Addendum No. 3
INVITING SEALED BIDS ITB No. 21/10039
Project: West Campus Laboratories Bldg. F Renovation

Issue Date: February 24, 2021

Project:
Pima Community College
WEST CAMPUS LAB BUILDING F RENOVATION

ADDENDUM NO. 3
February 24, 2021

LP3.11 LAB PLUMBING DETAILS

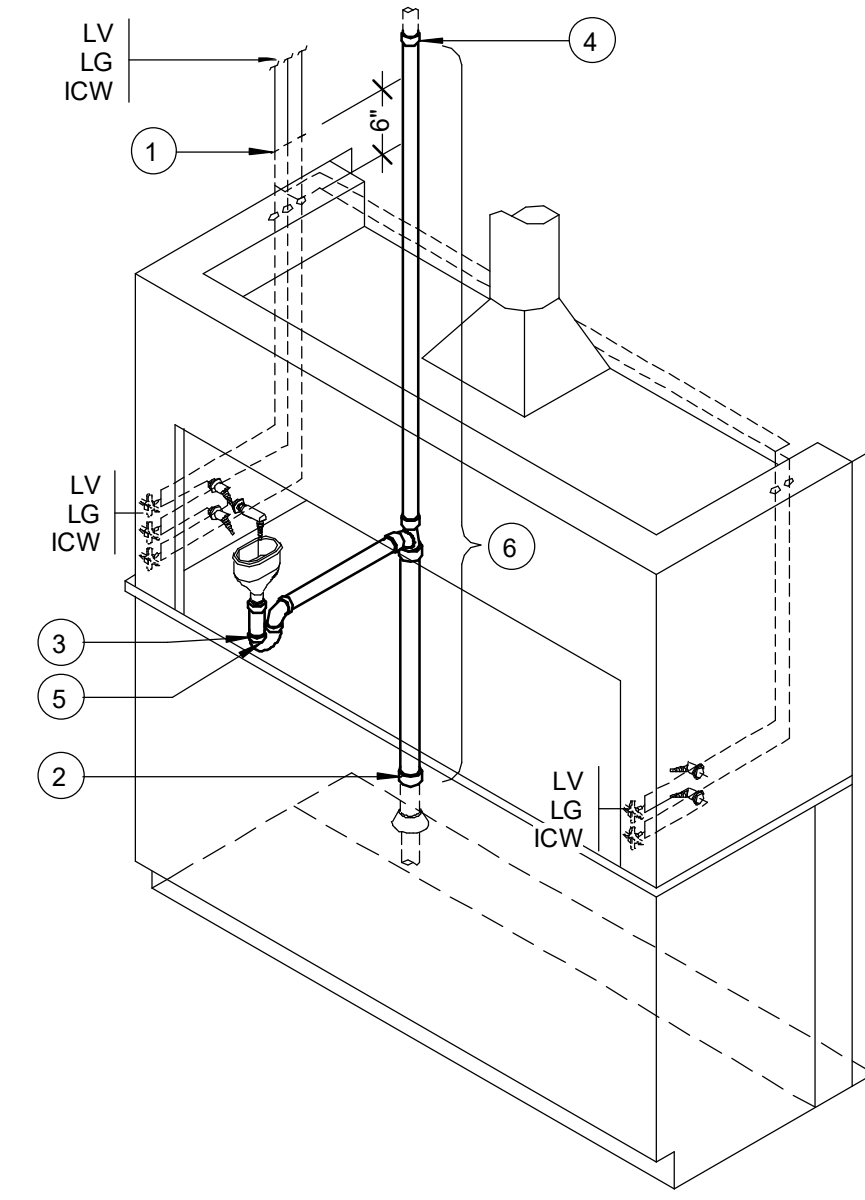
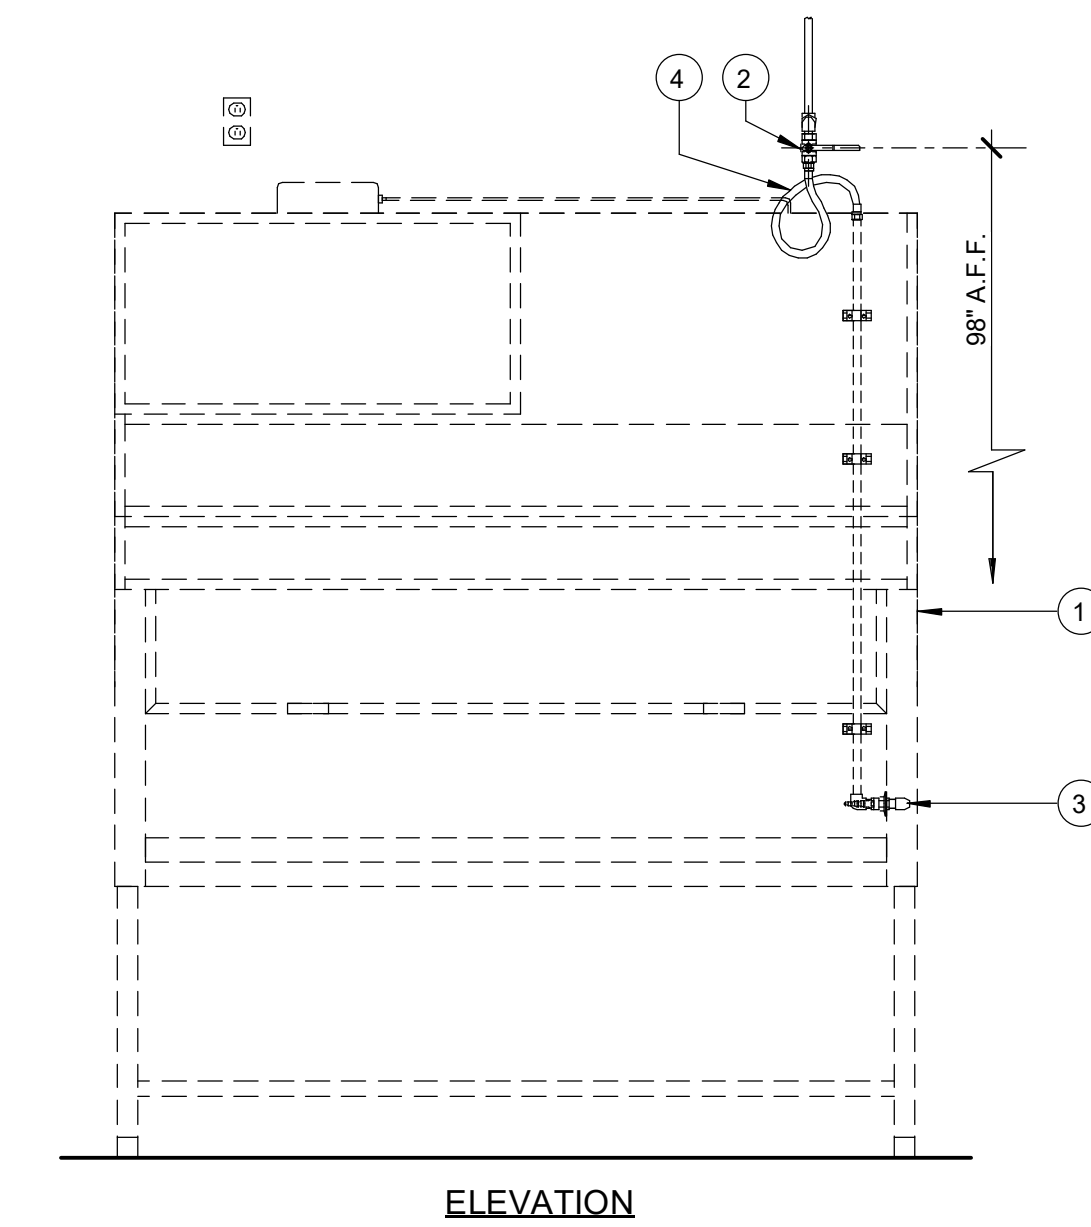
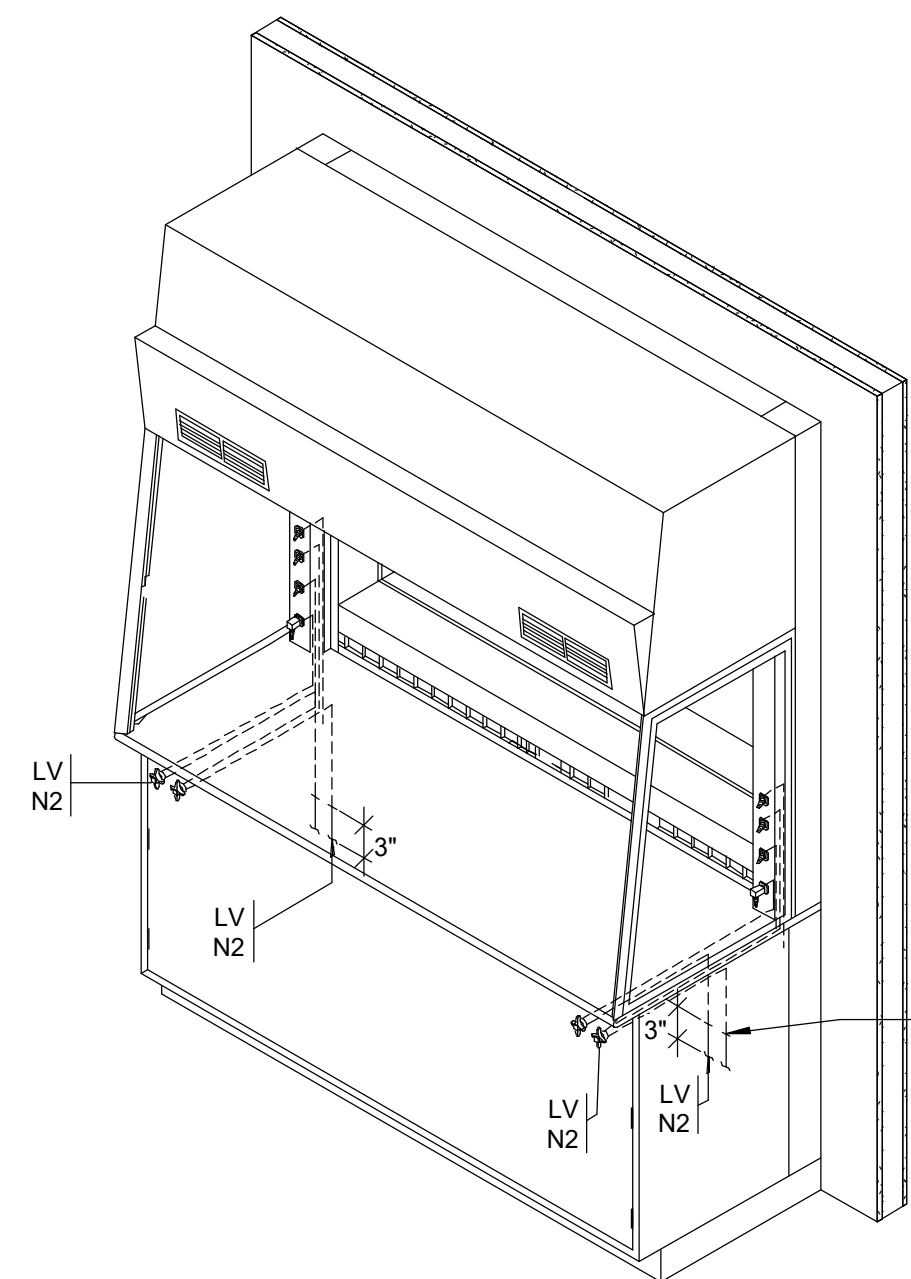
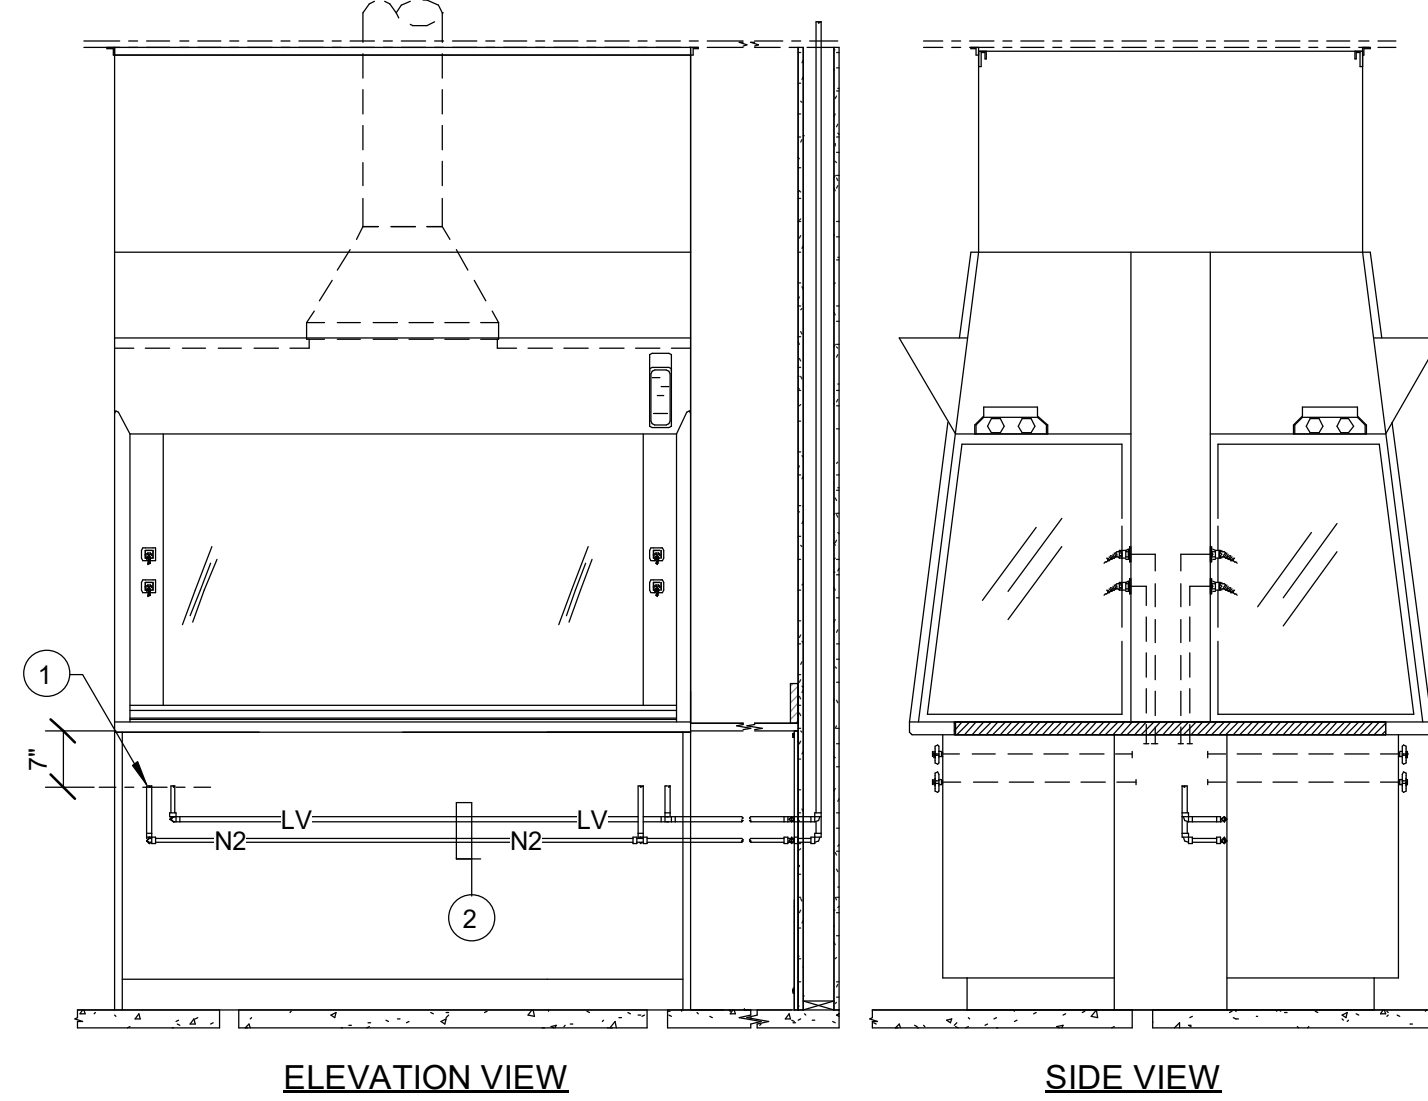
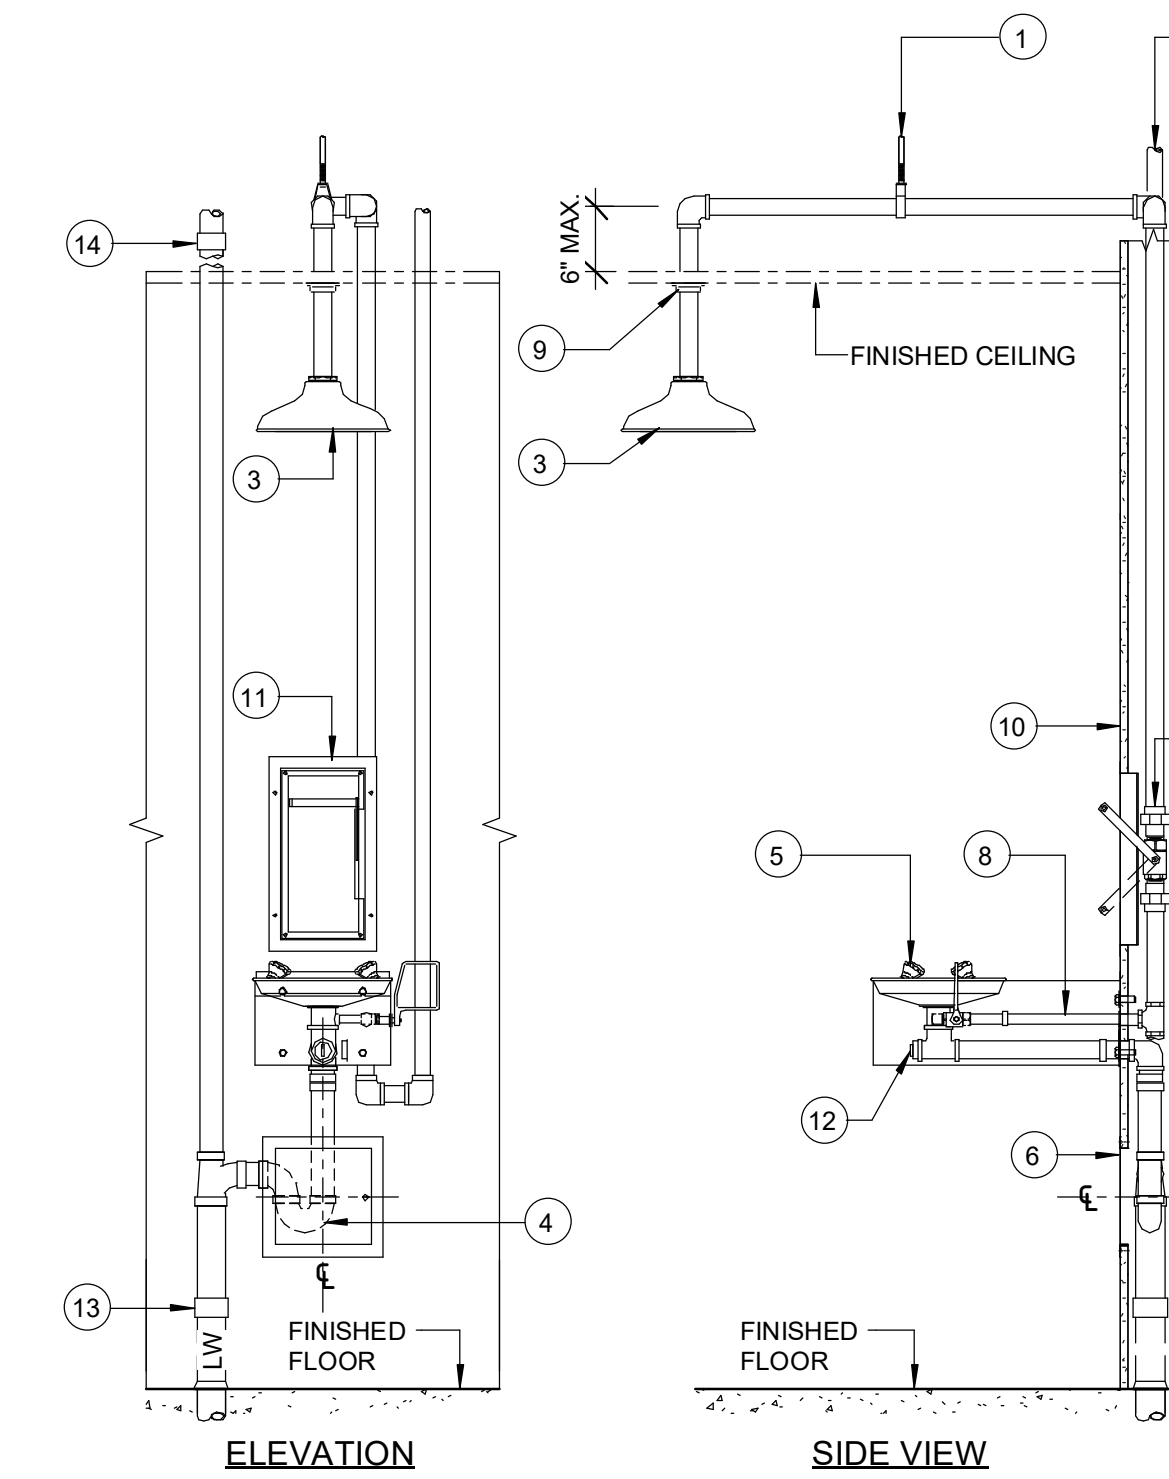
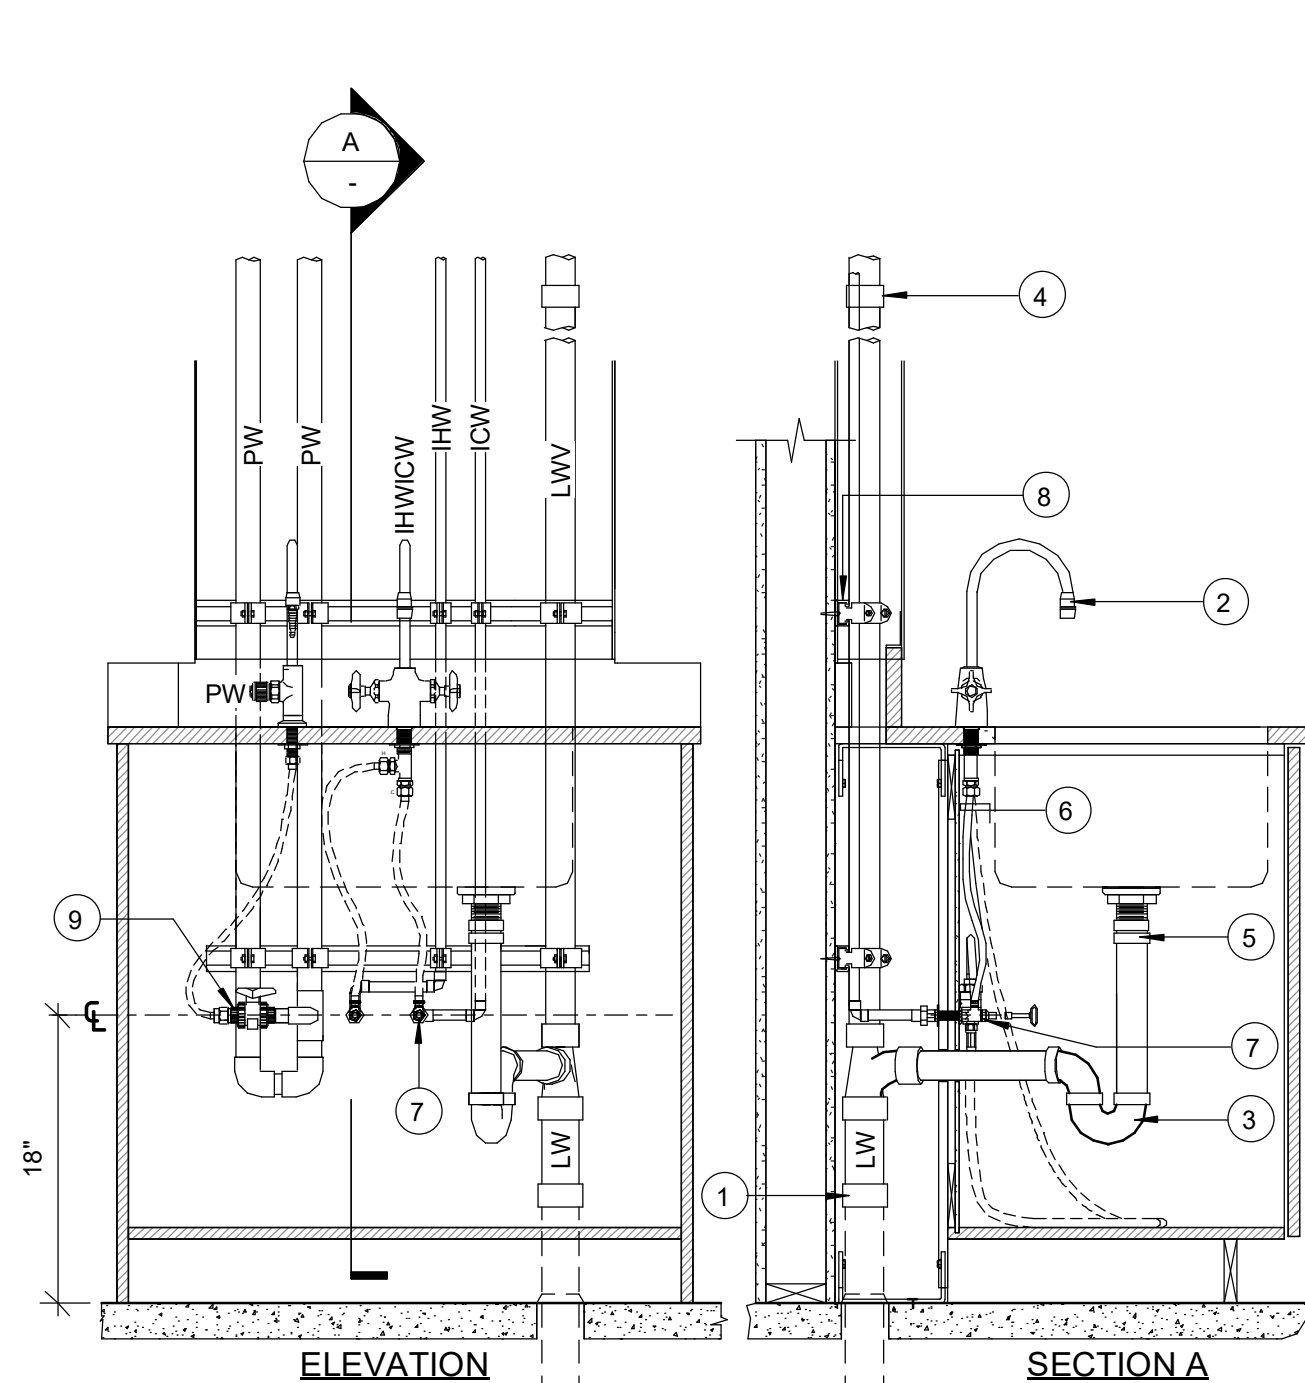
Question #33: Refer to Drawings – Lab Plumbing Details LP3.11. Something seems to have gone off-track with this drawing. There is no biddable, buildable information, no title block, date, AE seal, notes or scale, etc. It may be an early SD phase 'sketch' and not the intent for this drawing to be issued like this for bidding and construction. There are many other drawings and notes referencing this drawing and specific details. It is key for this PCC labs project. Please take a look at drawing LP3.11, correct and re-issue this sheet ASAP.

Answer #33: Refer to the attached BWS Addendum 3
